FILE P. I. No. 0006400, Cobb-Fulton Counties **OFFICE** Preconstruction
CSNHS-0006-00(400)
I-285 Ramp Meters from I-20, Fulton to
Cobb Parkway/I-285 41, Cobb **DATE** October 31, 2006

SUBJECT APPROVED PROJECT CONCEPT REPORT

Subject: Project Concept Reports for Ramp Metering Projects CSNHS-0006-00(335) Fulton-Forsyth Counties, CSNHS-0006-00(400) Cobb/Fulton Counties, and CSNHS-0006-00(401) Henry/Clayton/Fulton Counties

PROJECT CONCEPT REPORT

Location of Project in Cobb and Fulton Counties

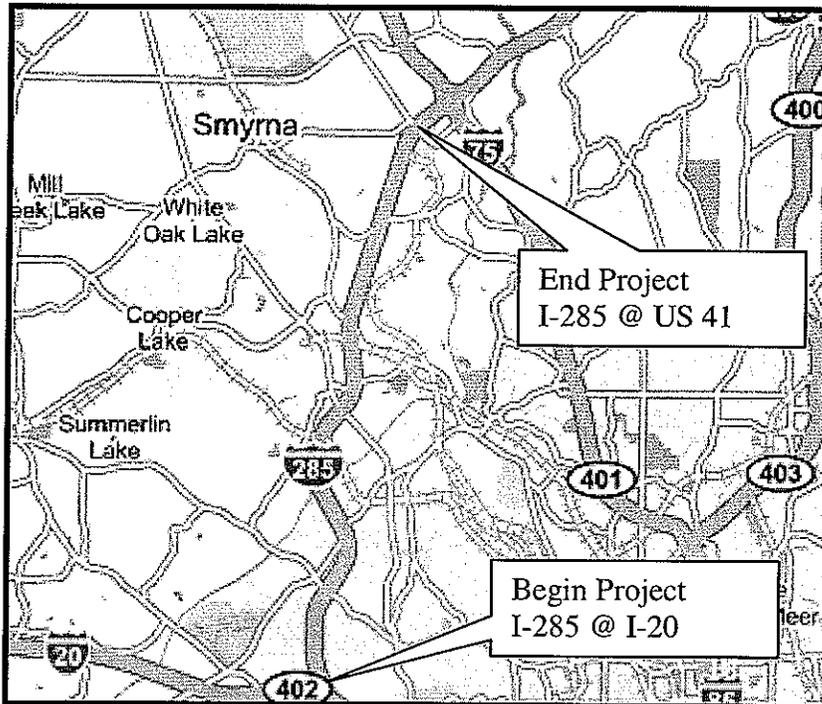
- Each project report includes a description and a figure showing the project area. The description texts should reference the figures, including page numbers.
